Subject:
A couple of questions about a Theremax build
From:
x
Date:
Monday, 3/14/2011 11:12 AM

Hello, Scott. I recently received a Theremax kit. It went together easily thanks to the excellent documentation, but I have a couple of questions regarding modifications.

Wide shot.jpg

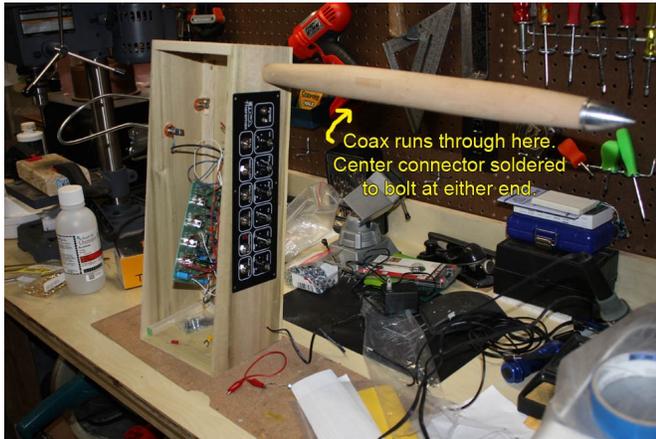
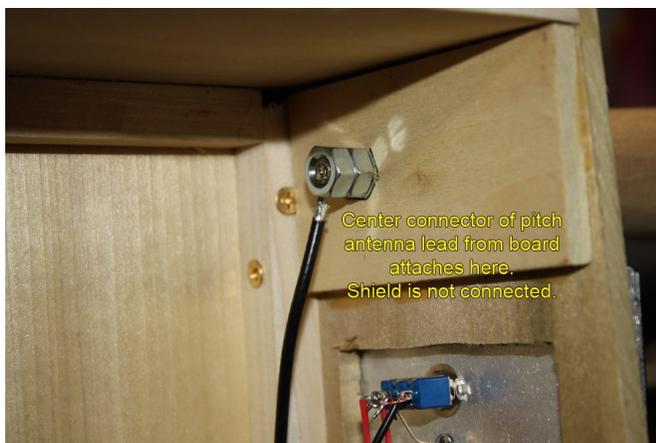
2. Since I really like the look of the antennas on the Moog Etherwave Pro, I am trying to reproduce that on my build. I have attached some photos, but the basic idea is a french rolling pin with a hole bored lengthwise through the center and a hanger bolt (also with a central longitudinal hole) on each end. I have a length of coax passing through the rolling pin with the center connector soldered to the hanger bolt at each end so that the entire unit can simply be screwed into a nut inside the case to which the center connector of the pitch antenna lead is soldered. The problem I'm having is that with this set up the entire horizontal length of the rolling pin acts as the pitch antenna (what I want is for a vertical piece of steel that will be attached to the end cap to serve as the antenna). My assumption is that this is happening because shield wire in the coax is not continuous from the circuit board out to the far end of the antenna arm. Is that correct? If so, I will need to think of a way to get around that while still having the antenna arm be easily removed and reattached. But before I tear it all apart, I want to make sure I'm thinking along the right lines.

About the pitch antenna extension arm, it would be necessary to make the run out to the vertical rod using shielded cable instead of just the single conductor afforded by the rod in the extension. A hollow extension would allow the shielded cable to make the run.

It looks like the shield is trimmed a bit too close to the internal wire in one of your images. It should be about 1/4" (5mm) away to prevent accidental contact. A bit of heatshrink or other tubing will help to ensure the nib of the clipped shield wires don't touch the antenna mount.

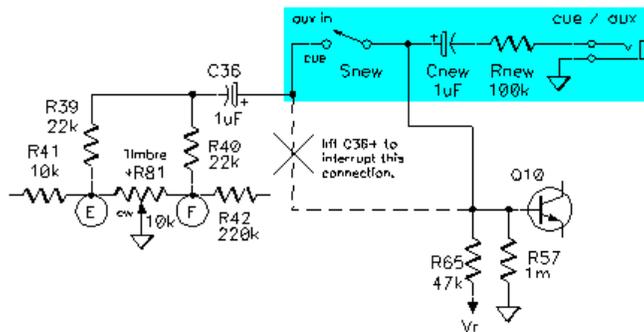
1. I need a pitch preview, and I found the schematic for that modification on the PAIA site. However, the schematic seems to say to disconnect the positive leg of C36. It also shows a switch, that I want to leave out of my modification since I don't have a need to introduce outside signals. When I tried the modification after lifting the positive lead of C36, I got very little signal at either the pitch preview or main audio outputs. When I tried it with the positive leg of C36 in place, I got much better signal at both the preview and main outputs. So I guess I have two questions, is the switch shown in the schematic necessary, and if I leave C36 in place, am I doing any damage? (I guess these questions presuppose that I have otherwise got the mod right - I simply ran a fly wire connected to R65 with the new capacitor and resistor in place to the mute jack.)

About the cue modification, the reason the signal was lower with C36 lifted is that R65 was out of the circuit and not working to steady the audio fluctuations at the Vr potential (half the dc supply), and, the connection to the VCA/Audio output section was open. It is OK to make the tap at R65 as you have done. The switch is only needed for opening the theremin audio and replacing it with an external audio signal. Then, just to be sure, you will have substituted the Cue output for the wire (T) that had been going to the Mute jack, right? They should not both be connected at this new, Cue connector.

This cue circuit allows listening to a preview of the pitch being produced before bringing up the volume on a note. Tapping the audio path at the location shown in the drawing provides a constant level output to drive a small headphone amp such as our [9605 Headphone Buffer Amp](#).

The same jack can also be used as an auxiliary input to pass external signals through Tmax's VCA. When the added switch is closed, external inputs are mixed with Tmax's internal tone circuitry. With the switch open the internal tone circuitry is replaced with the external signal.
